TITLE:	IMAGE FUV II ACTEL DESIGN TDC ACTEL
DRAWN BY:	HEETDERKS
DATE:	1AUG97
DWG NO:	8023-V7
REV	F
FILE NAME:	TDC.SCH

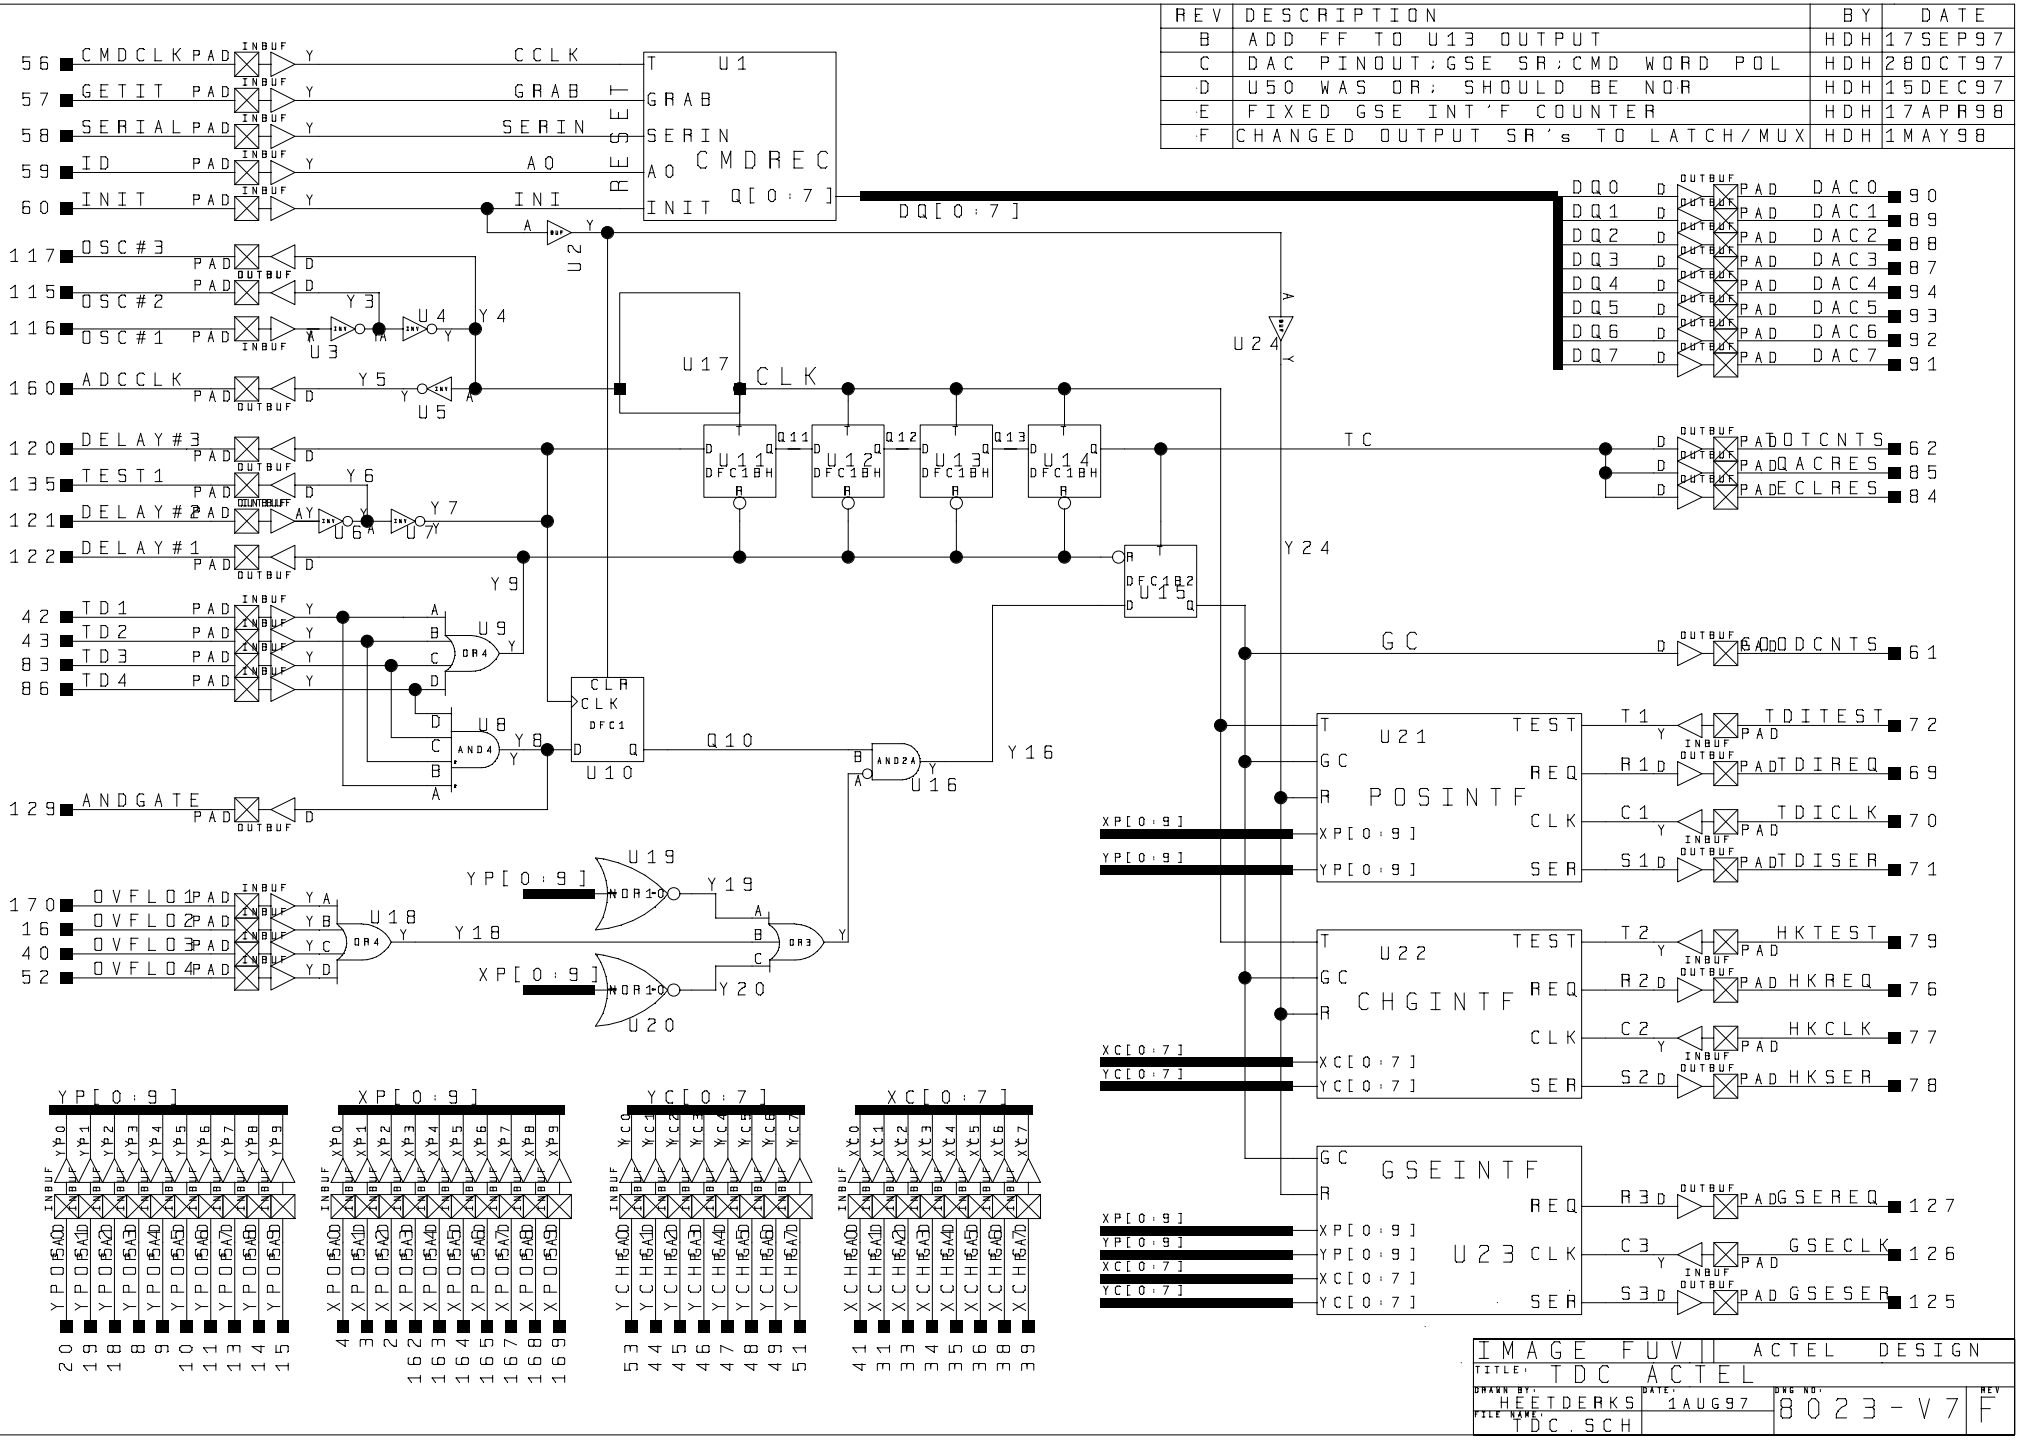
REV	DESCRIPTION	BY	DATE
B	ADD FF TO U13 OUTPUT	HDH	17SEP97
C	DAC PINOUT;GSE SR;CMD WORD POL	HDH	28OCT97
D	U50 WAS OR; SHOULD BE NOR	HDH	15DEC97
E	FIXED GSE INT'F COUNTER	HDH	17APR98
F	CHANGED OUTPUT SR's TO LATCH/MUX	HDH	1MAY98
